## ERRATA

### PTI DC10.2-06: Construction and Maintenance Manual for Post-Tensioned Slab-on-Ground Foundations Third Edition 2006

#### DC-10 Slab-on-Ground Committee

The following errata items were added on **10/4/2010**:

##### “5.2 General Installation Procedures”

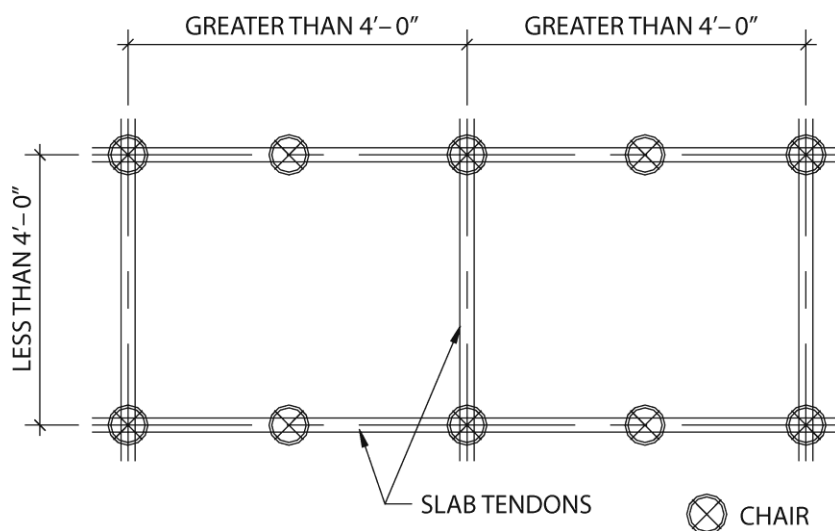
#### Page 13, Section 5.2.3:

“3. All individuals involved in the installation and stressing operation should be certified as having successfully completed....”
